Request for Class II Permissive Change

FCC ID: BV2-AH-W200

Date: 2012-7-30

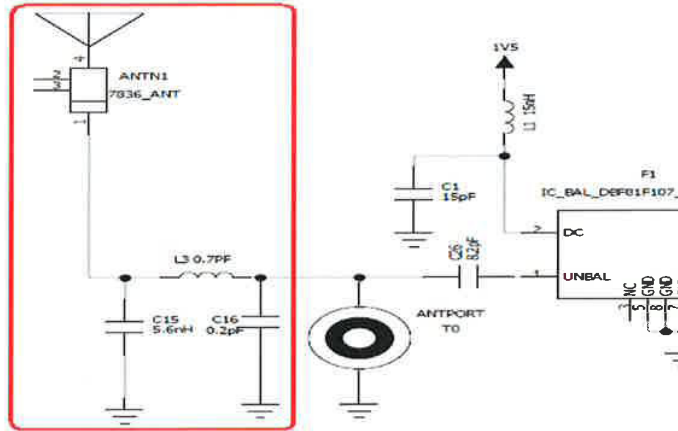
We change the antenna and matching circuit, as following:

Change Chip antenna 2.45G CAN431111500245 size:7.8*3.6 to Chip antenna 2.7G CAN4311115002701KRKCG 7.8*3.6

Remove the C16 CAP C0402,50V,0.2pF,+5%,NPO,PN:GRM155C1HR20WA01D

Change L3 CAP C0402,0.7pF,+5%,NPO,PN:GRM155C1HR70WA01D to L3,0402, 4.7nH,300mA,+0.3nH,PN:LQG15HS4N7S02

Change C15 5.6nH,0402/+0.3% 300mA,P/N:LQG15HS5N6S02D LF to C15 1.0pF,0402,PN:GRM1555C1H1R0CA01D
